Access Compliance Report

Public Rights-of-Way

(Curb Ramps)

Intersection ID: 29145	Main Street: CRAWFORD_BROOK_LN	Cross Street: DEATON_HILL_DR	Location: SW
ADA ID: 9B841A7B433E	Ramp Type: BlendTrans1	Initial Pass/Fail: Fail	Overall Compliance: No
Severity Score: 10			
Codes/Mitigation Info/Possible Solution		Field Measurements/Component Compliance

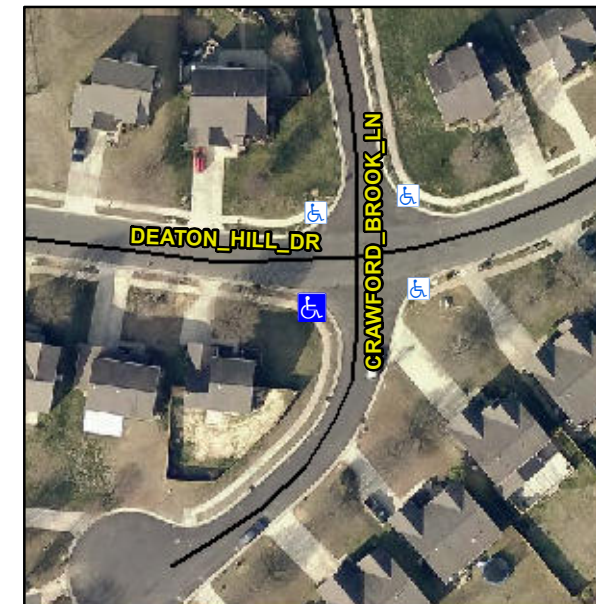
Not Found, R304.5.1, R304.5.3

Compliance	Description	Data	Compliance	Description	Data
N/A	Ramp Length (in)	48.0	Yes	BlendTrans Slope (%)	4.8
No	Ramp Width (in)	47.5	No	BlendTrans XSlope (%)	3.2
N/A	Flare Type LT	N/A	N/A	Flare Type RT	N/A
N/A	Flare Slope LT (%)	N/A	N/A	Flare Slope RT (%)	N/A
N/A	Flare Traversable LT?	N/A	N/A	Flare Traversable RT?	N/A
N/A	Landing Length (in)	N/A	N/A	DWS Provided?	N/A
N/A	Landing Width (in)	N/A	N/A	DWS Contrast?	N/A
N/A	Landing Slope (%)	N/A	N/A	DWS Length (in)	N/A
N/A	Landing X Slope (%)	N/A	N/A	DWS Full Width?	N/A
N/A	Landing Curb? (Y/N)	N/A	N/A	DWS Offset (in)	N/A
N/A	Shared Landing?	N/A			
N/A	Gutter Ponding?	N/A	N/A	Gutter Slope (%)	N/A
N/A	Gutter Lip Ht (in)	N/A	N/A	Gutter X Slope (%)	N/A
N/A	Painted X Walk1?	No	N/A	Painted X Walk2?	No
	X Walk 1 Direction	To E		X Walk 2 Direction	To N
	X Walk 1 Width (in)	N/A		X Walk 2 Width (in)	N/A
	X Walk 1 Slope (%)	1.5		X Walk 2 Slope (%)	0.0
	X Walk 1 X Slope (%)	1.6		X Walk 2 X Slope (%)	0.9

N/A	Ramp inside XWalk1?	N/A	N/A	Ramp inside XWalk2?	N/A
	Road Slope (%)	3.5		Clear Space?	N/A
	Road X Slope (%)	0.1	N/A	Clear Space to XWalk (in)	N/A
N/A	Any Obstructions?	N/A	N/A	Storm Grate/Utility Hazard?	N/A
	Obstruction Type			Storm Grate/Utility Type	
		N/A			N/A
			Yes	Surface Condition? (G/P)	Good
			No	Curb Slope (%)	8.1

Remove & Replace Curb Ramp With Two New Directional Ramps or Equivalent.
